CALIFORNIA COASTAL COMMISSION

ADDENDUM

DATE: July 12, 2005
TO: Commissioners and Interested Parties
FROM: South Central Coast District Staff
SUBJECT: Agenda Items W14a & W15, Wednesday, July 13, 2005, University of California at Santa Barbara Long Range Development Plan Major Amendment 1-04 & NOID 2-04 (San Clemente Housing Project)

Exhibit 5a
LRDPA 1-04 & NOID 2-04
Certified Height Limit

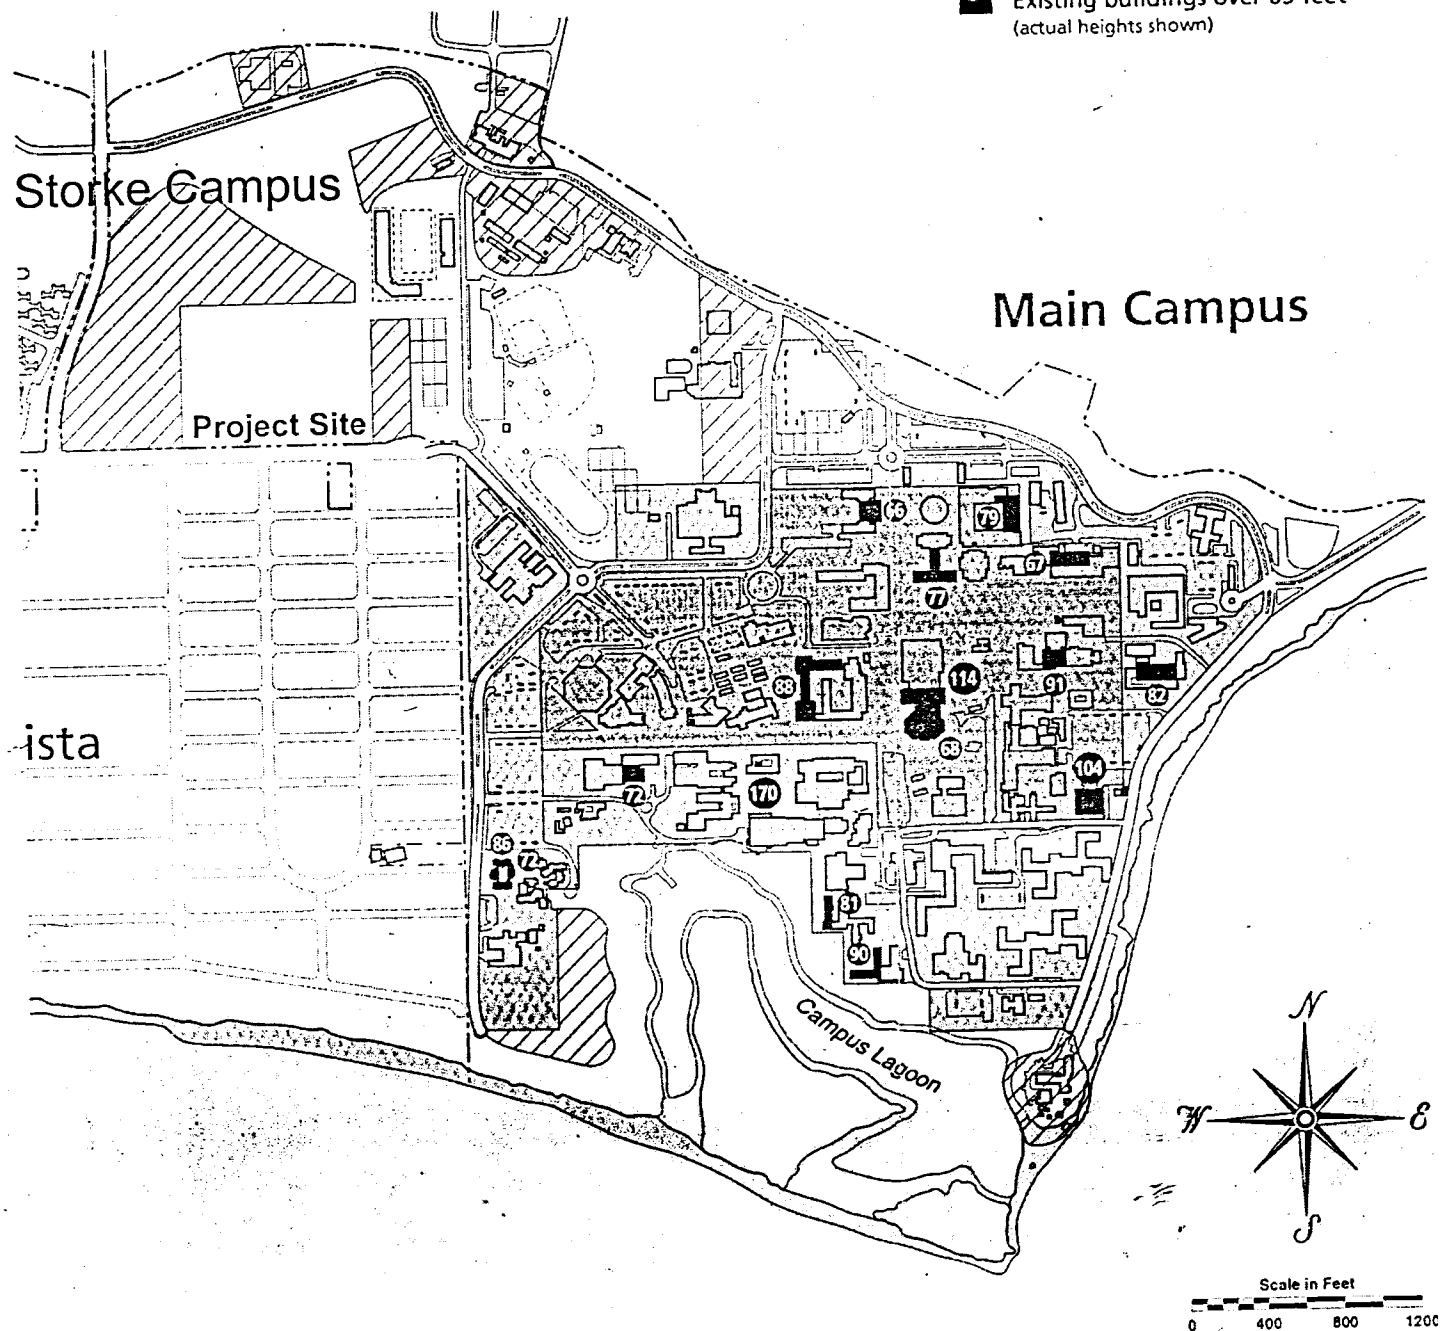
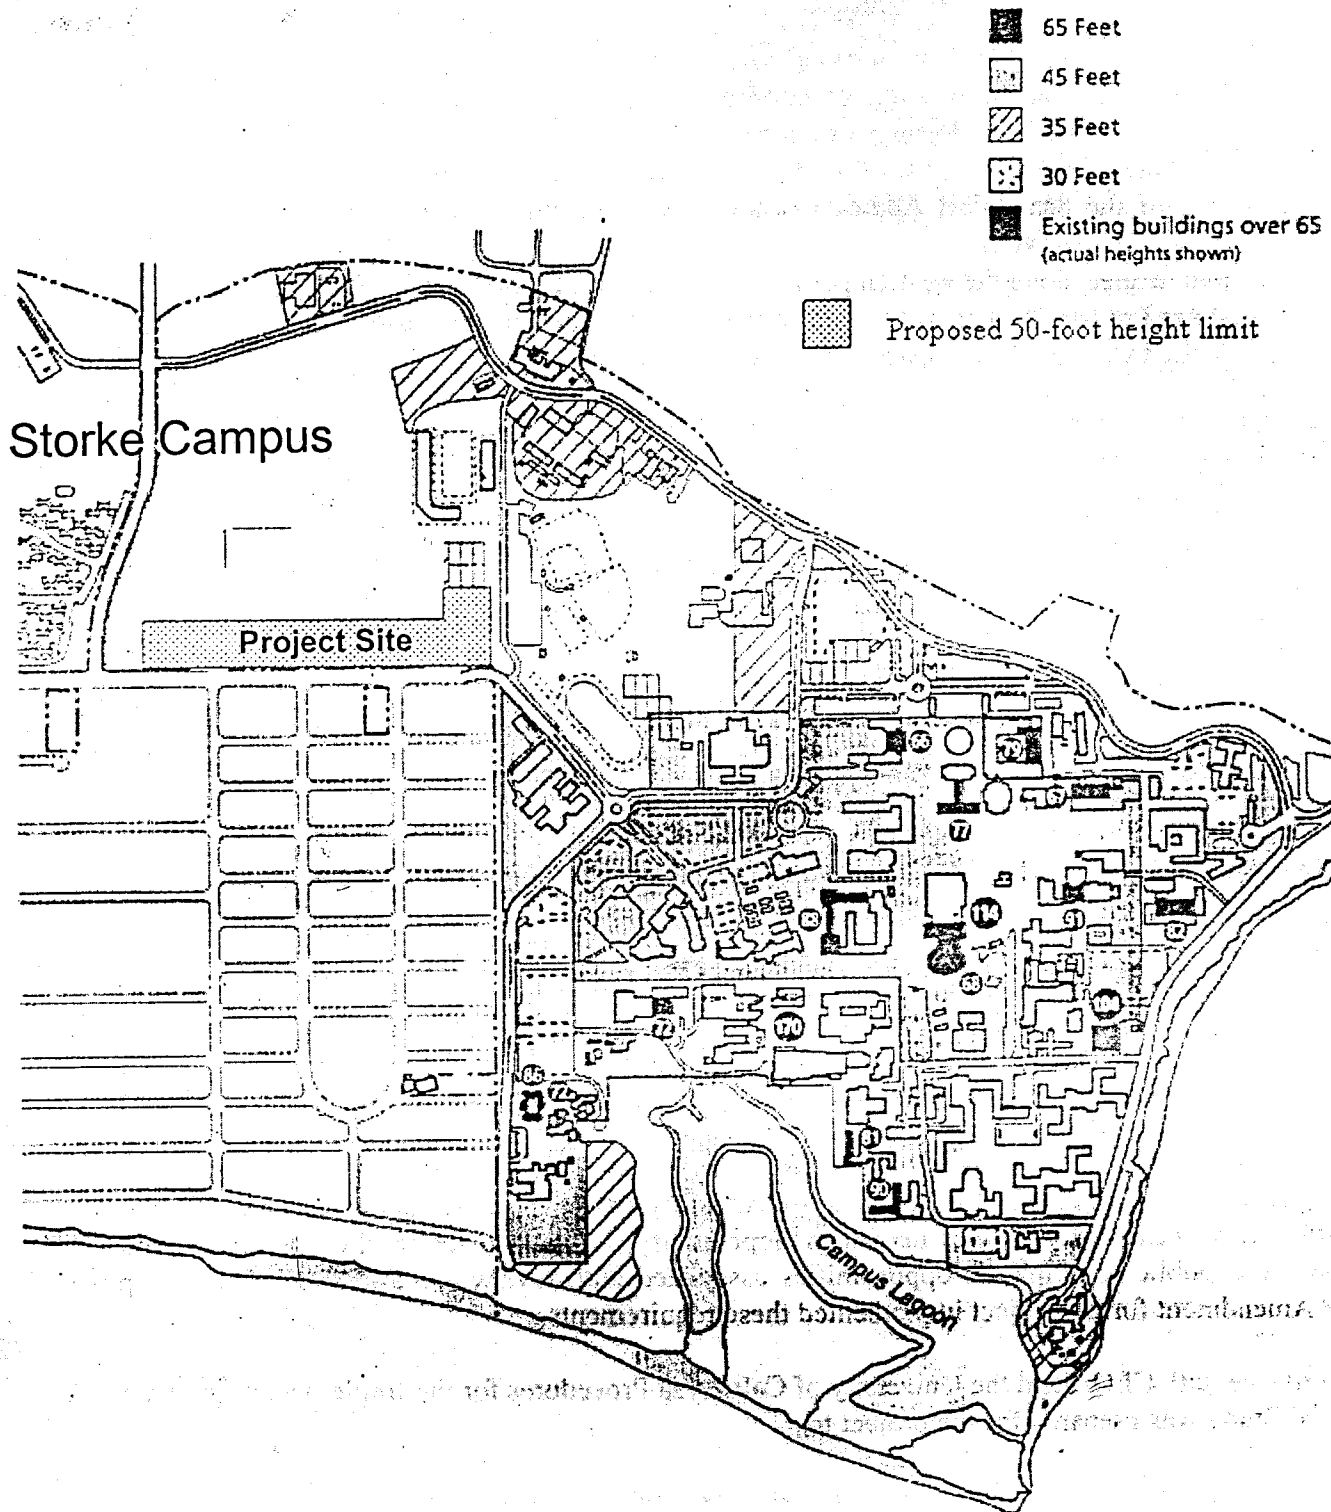
Figure 16, Campus Building Height Limits, shall be modified to show a maximum building height of 35 feet above existing grade, in the location of Parking Lot #30.
